Product / Process Change Notification

PCN No : DN20xxx

- **Subject of change:** Revise 1.Caution label of MBB (Moisture-Barrier Bag)
2.HIC (Humidity Indicator Card)
- **Change Purpose:** Follow JEDCE STD – 033 of new version(D)
- **Change Description:** Modify description of caution label on MBB & Update the HIC indicated point from 6 to 3 points.
- **Change Evaluation Result :** Follow JEDEC standard.

1. Caution label on MBB (Moisture-Barrier Bag) :

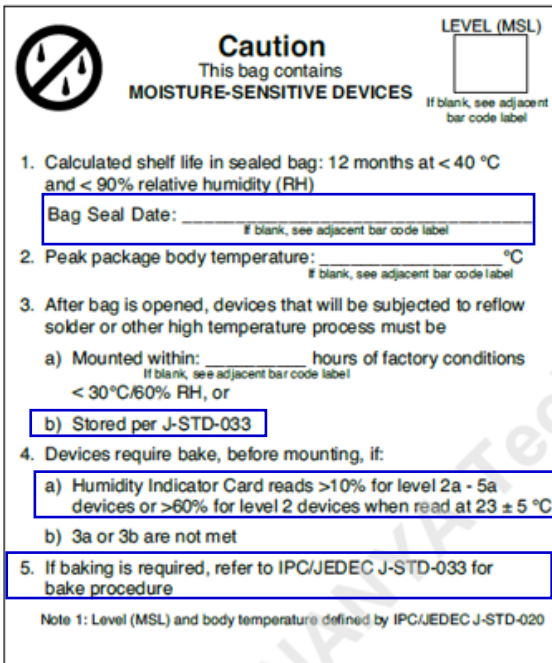
- 1) Baked, read & stored conditions update to follow J-STD-033. There is no size change of caution label.
